TOWN OF WEST WARWICK
REQUEST FOR PROPOSALS (RFP)

GENERAL CONTRACTOR
30 Payan Street Renovation

ADDENDUM #2
Posted 2/12/2026

RFQ/P REFERENCE NUMBER: 2026-08
RFP RELEASE DATE: January 27, 2026

Drawing Number
A1.10

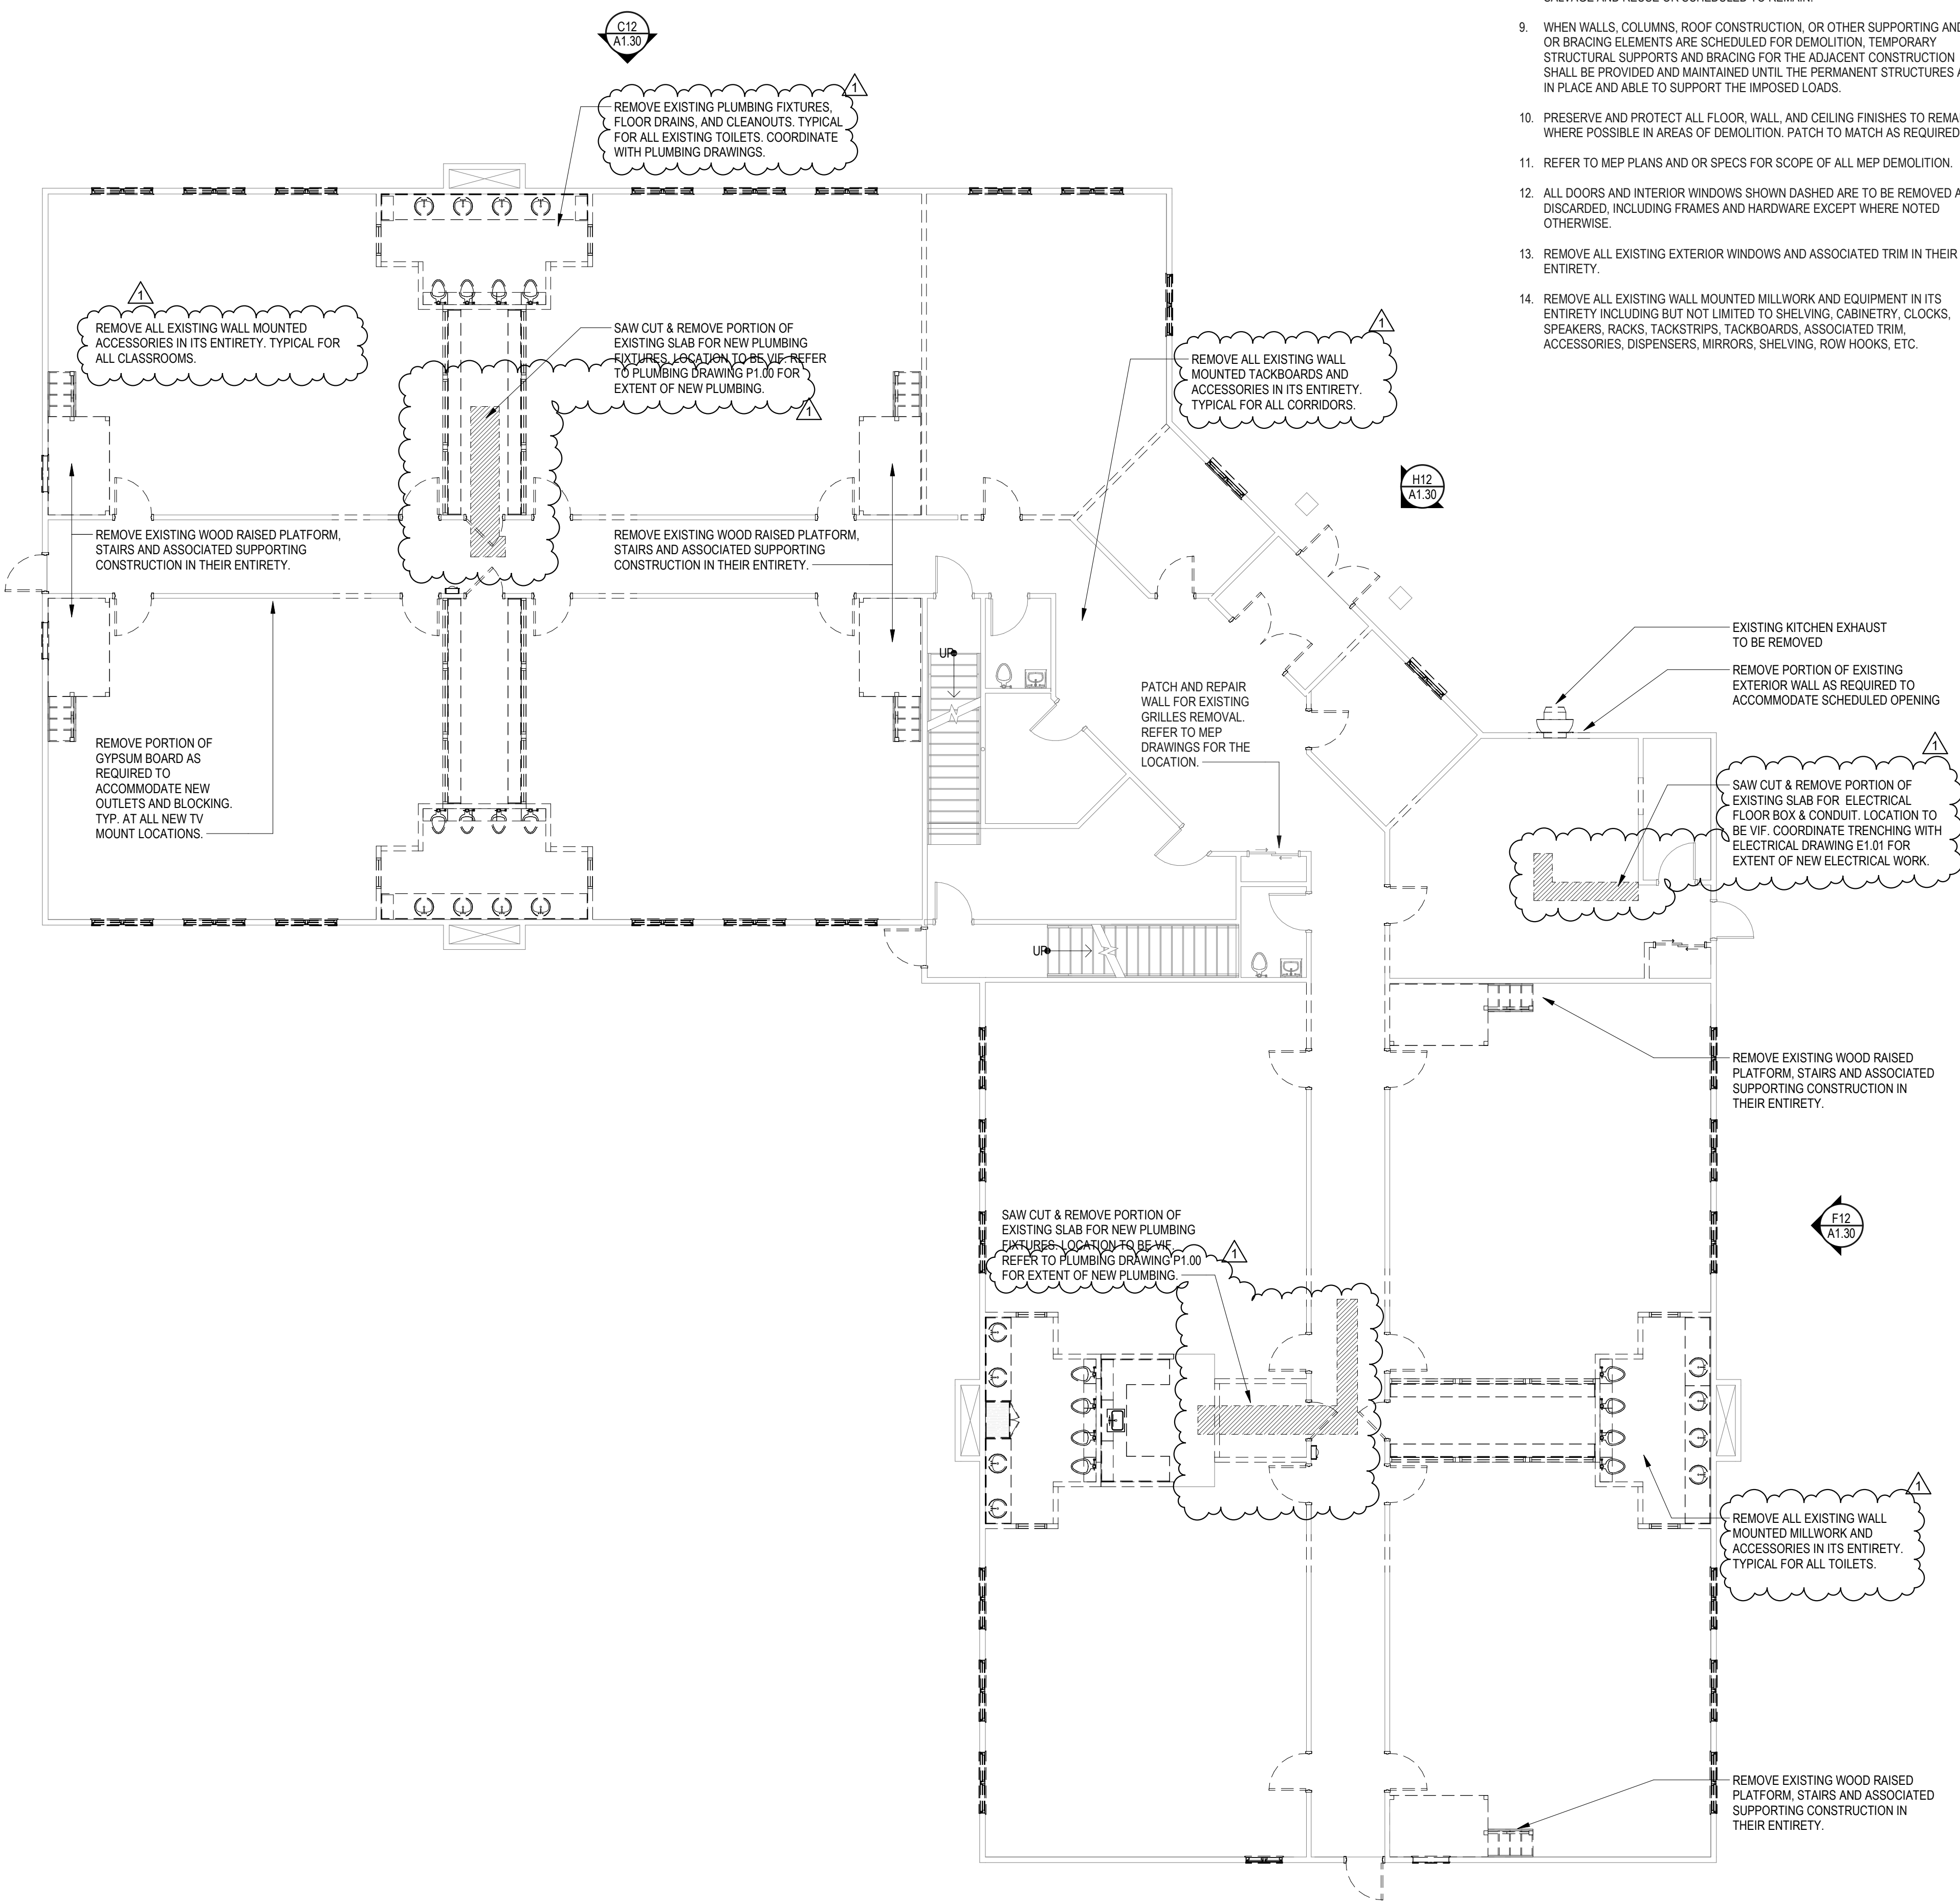
1. A1.10 DEMOLITION FLOOR PLANS
 - Coordinated slab cut with plumbing and electrical drawings per RFI A-01.
 - Added typical demolition notes for corridors, classrooms, and toilets per RFI A-40.
2. A1.11 DEMOLITION ROOF PLAN
 - Revised the demolition note to remove requirement for removal for that all gutters and downspouts as they are existing to remain per RFI A-12.
3. A1.30 DEMOLITION EXTERIOR ELEVATIONS

A1.30

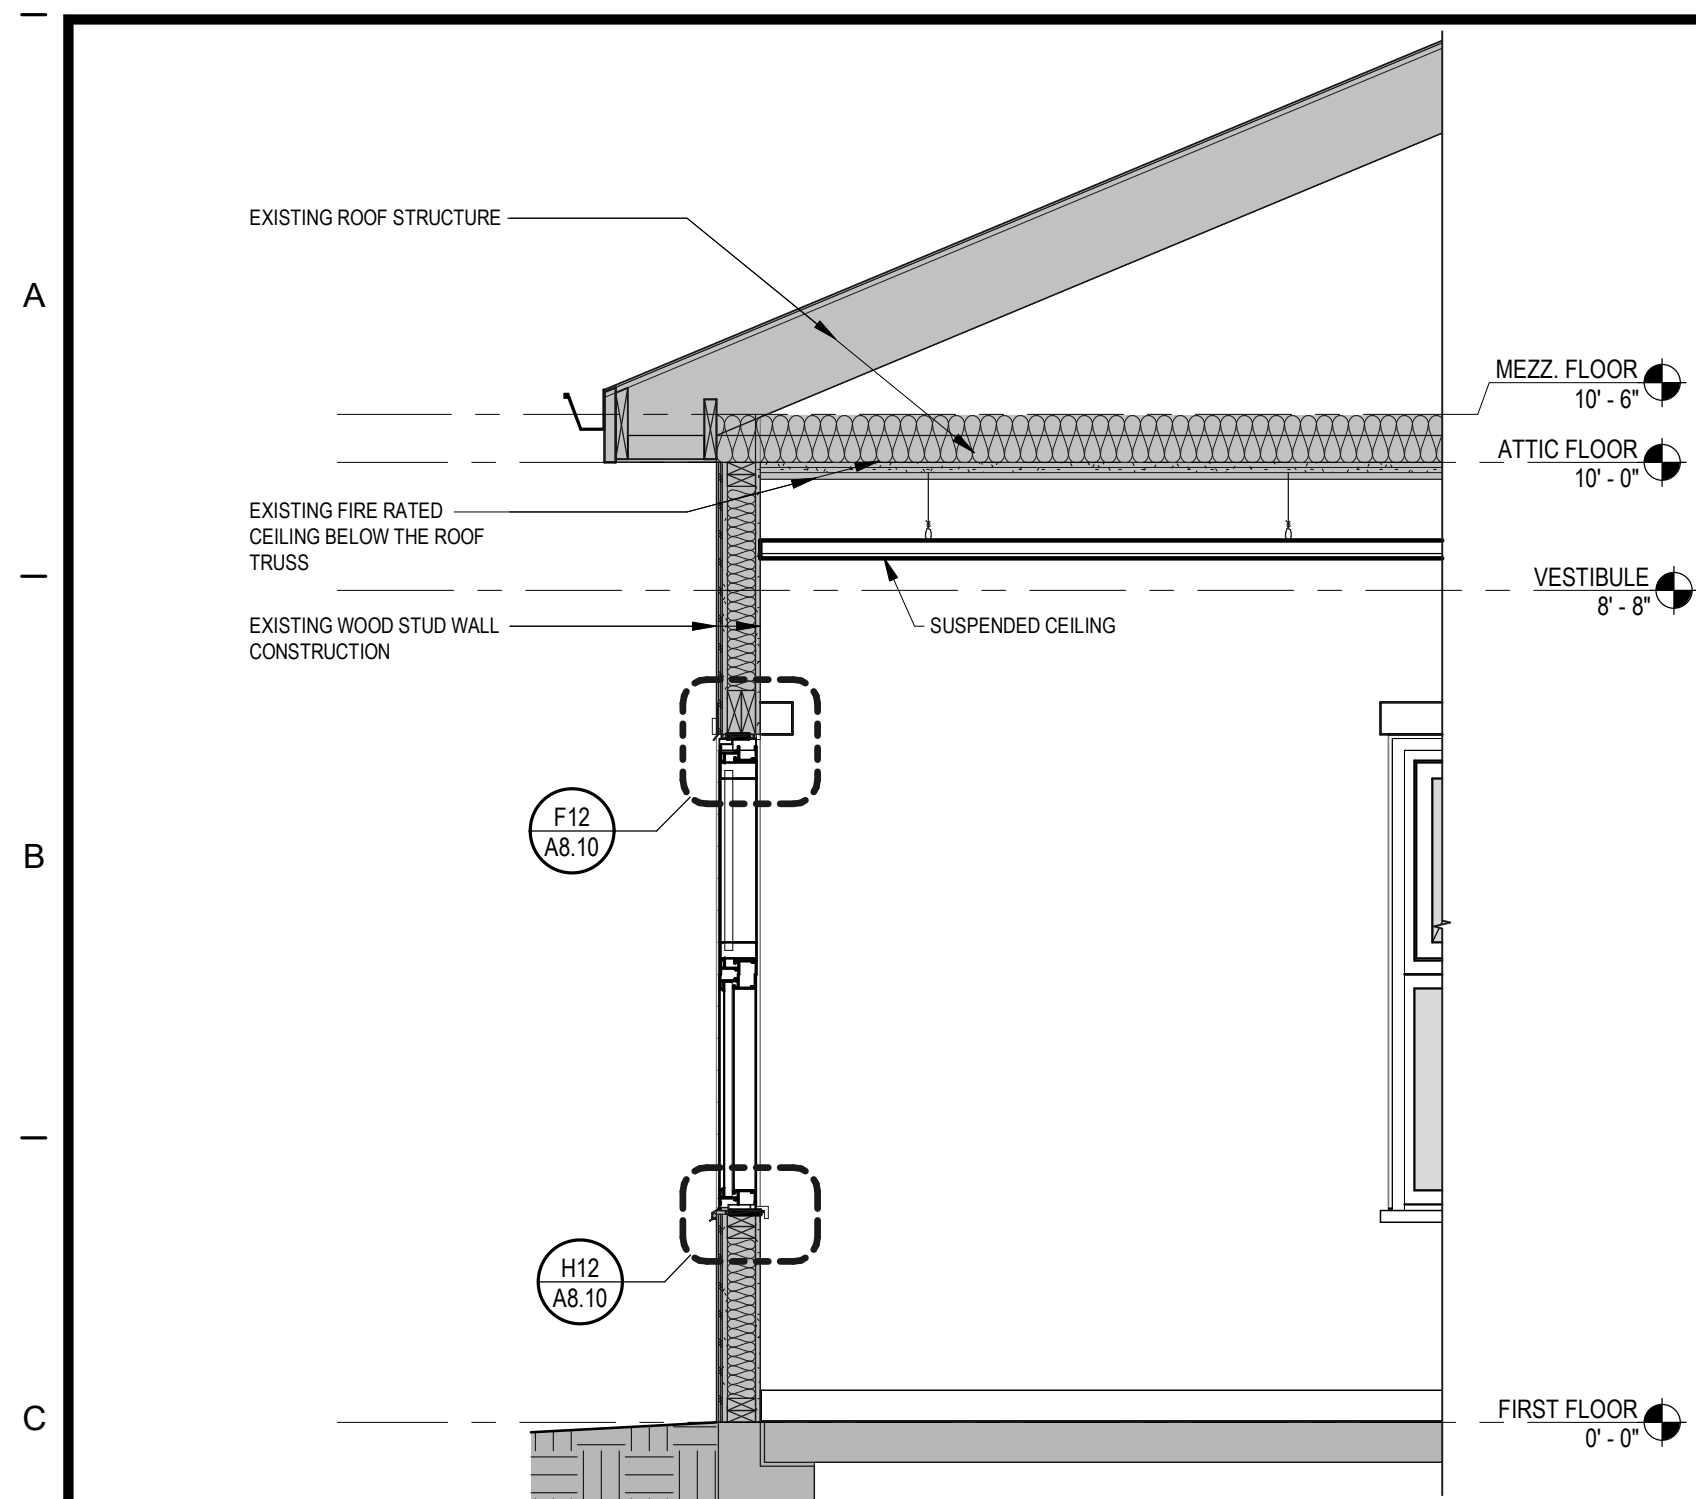
- Revised the demolition note to remove requirement for removal for that all gutters and downspouts as they are existing to remain per RFI A-12.
4. A2.10 MAIN LEVEL FLOOR PLAN, SECTIONS, & DETAILS

A2.10

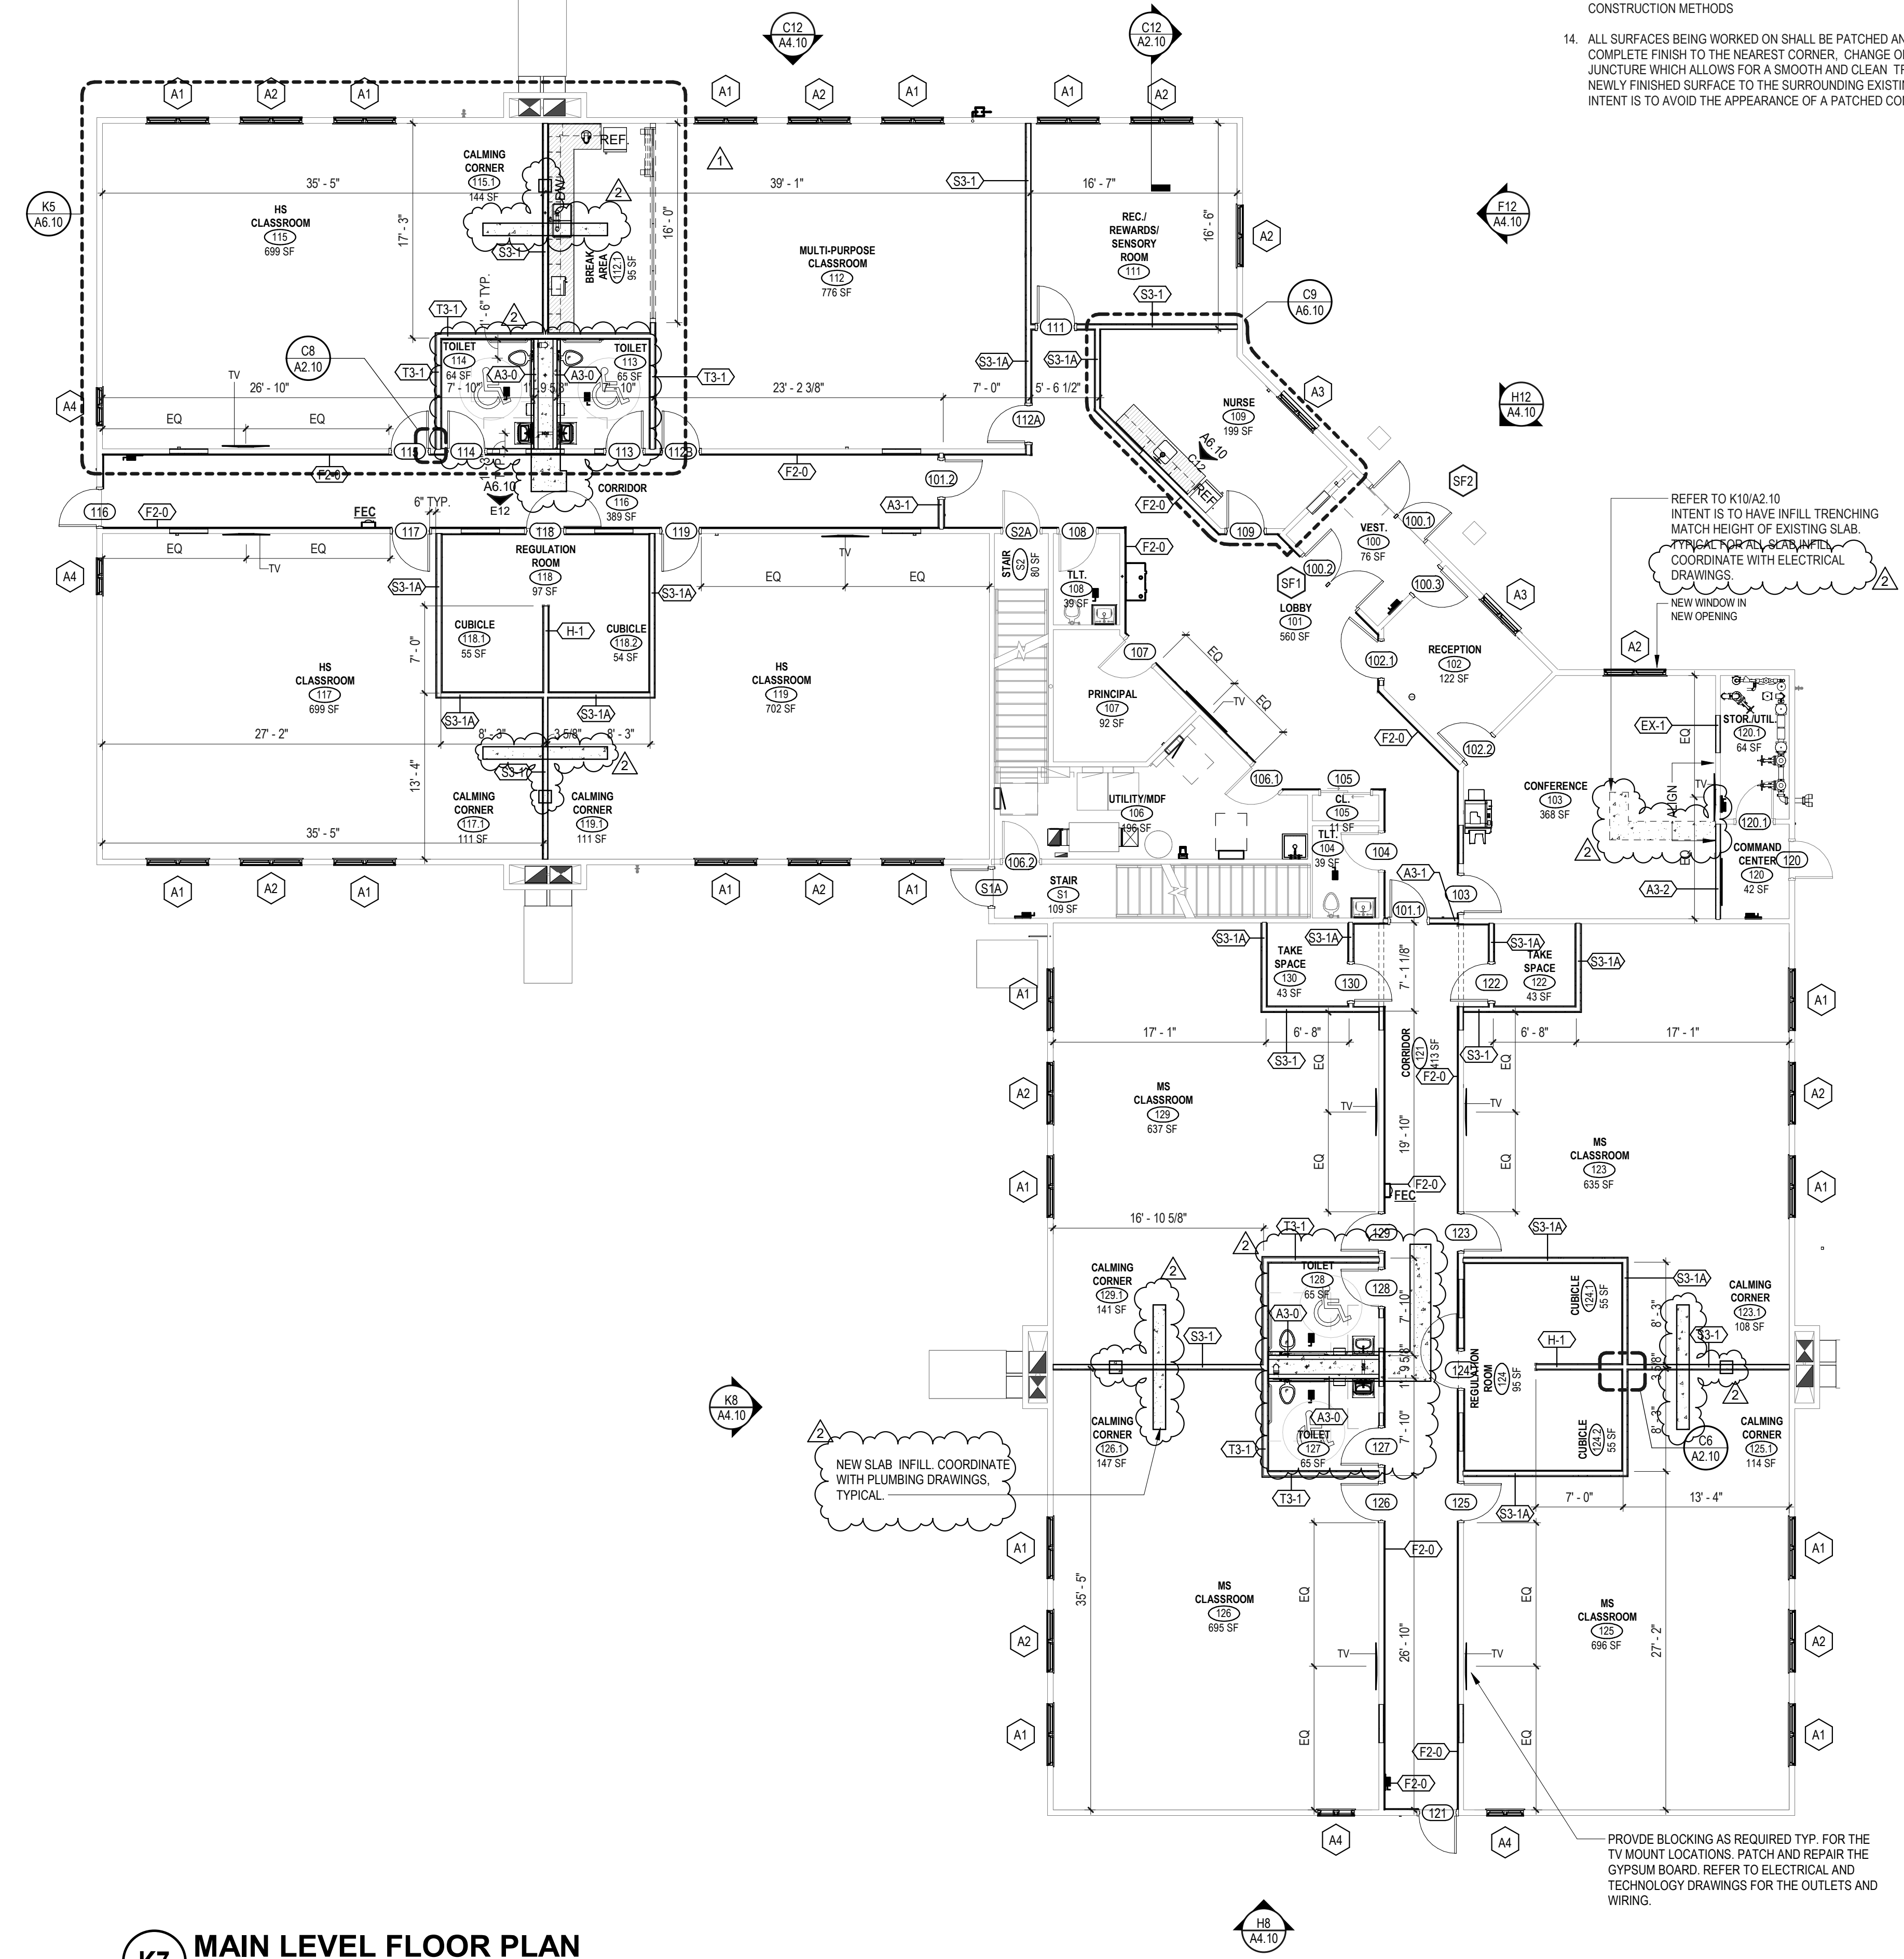
- Coordinated slab infill with plumbing and electrical drawings per RFI A-01.
 5. A2.30 ROOF PLAN & ROOF DETAILS
 - Added a note on drawing F12 to indicate that all gutters are to remain existing per RFI A-14.
